# **Town of Brunswick, Maine**

### **APPROVED FINDINGS OF FACT REQUEST FOR CERTIFICATE OF APPROPRIATENESS FOR ADDITIONS VILLAGE REVIEW BOARD**

**PROJECT NAME:** 159 Park Row Ramp and Lobby Addition

**CASE NUMBER:** VRB 25-021

3 INTERIOR ELEVATION @ BAY WINDOW  
A302

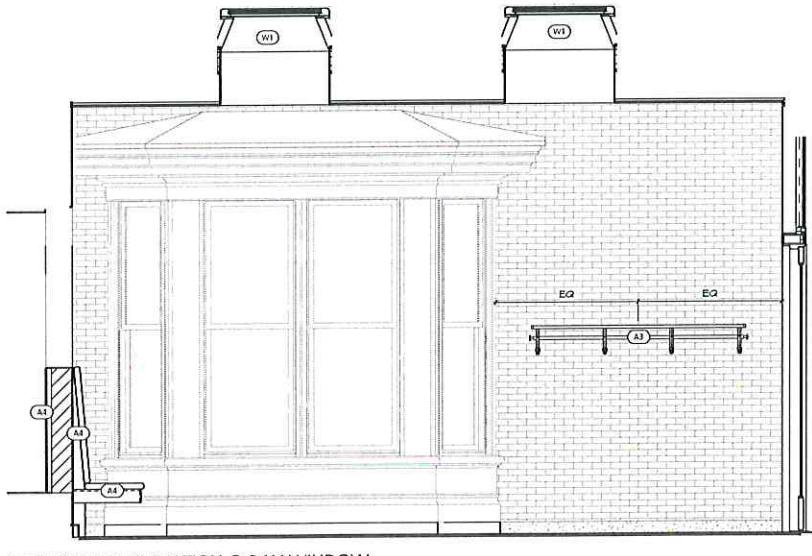
The new addition will be built around an existing bay window on the north side of the building. Rather than remove the window, which will now be interior to the building, the applicant has chosen to leave it in place and utilize it for museum displays.
